REM  
approved  
Plt 35 Opp  
Plt 39 Opp  
Plt 40 As

Project <b>Land at Tappers Farm Oxford Road, Bodicote</b>		Date <b>28.09.23</b>	Status <b>Planning</b>	
Drawing Title <b>Elevations compared: REM approved and Tech design proposals</b>		Scale <b>1:100 @ A1</b>	Drawn by <b>CAB</b>	Checked by <b>-</b>
Project No. <b>22-029</b>		Drawing No. <b>P/HT/201 / -</b>	Revision

Technical  
design stage  
adjustment  
Plt 35

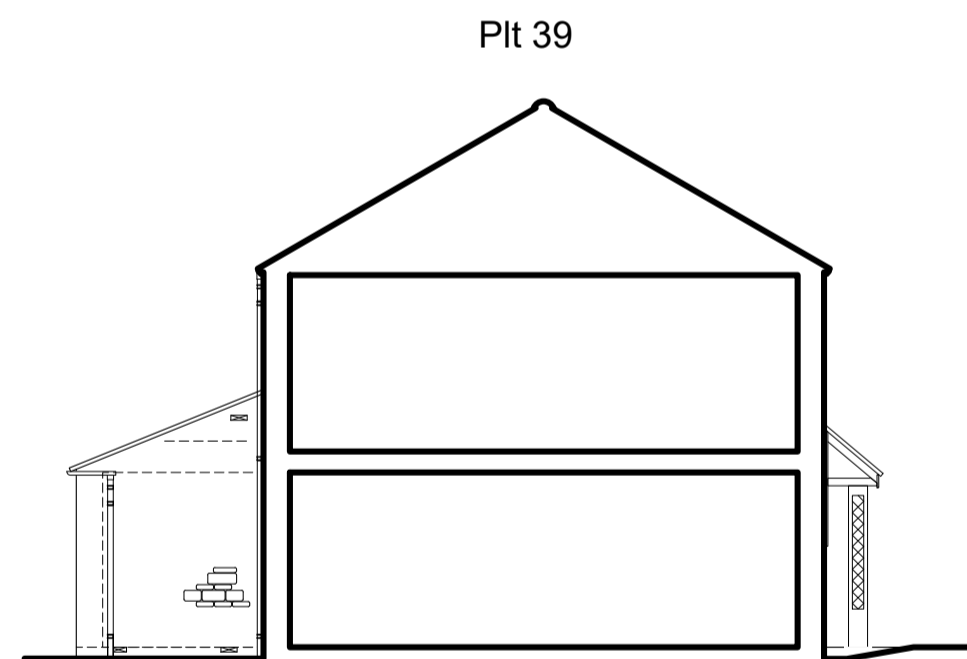
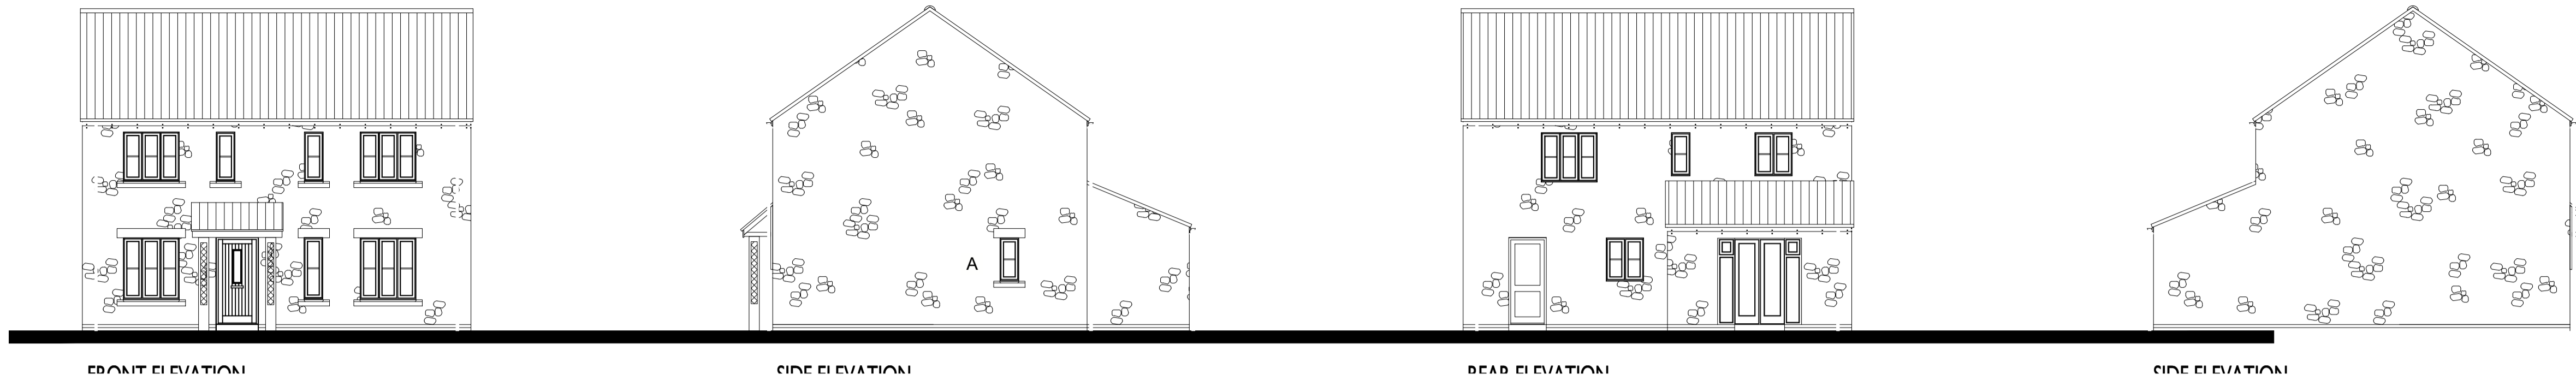
Notes:  
- garage shown for completeness.  
- window 'A' omitted due to attached garage  
- window 'B' added to Utility Room, overlooking private parking of this dwelling

Technical  
design stage  
adjustment

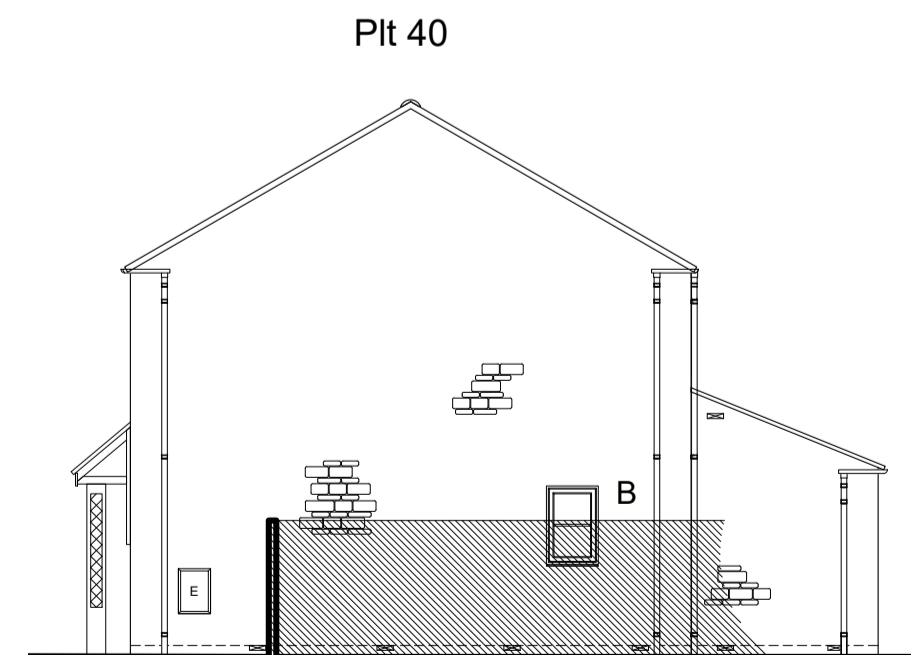
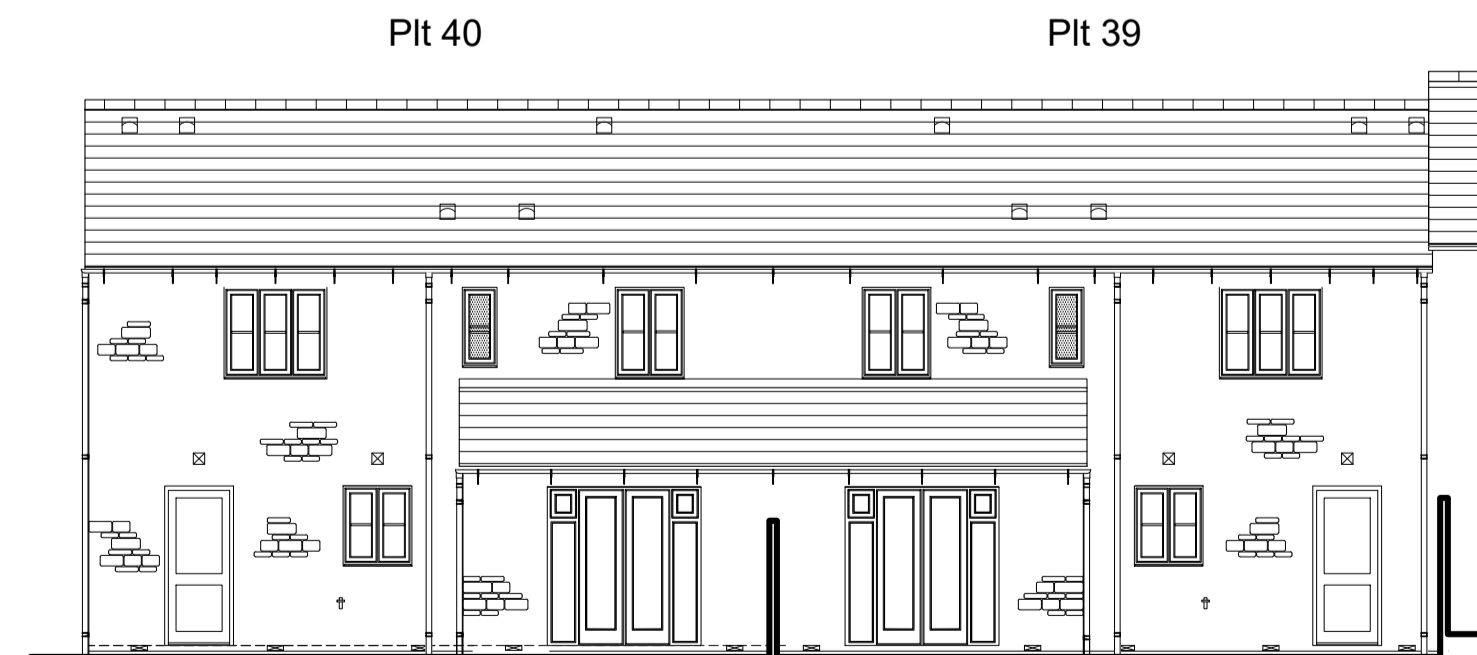
Notes:  
- window 'B' added to Utility Room, overlooking private side garden and screened by boundary fence.  
- Plt 39/30 roof pitch reduced from 35 to 30 to enable uniform gable abutment with Plt 38 and avoid pushing Plt 36-38 ridge too high.
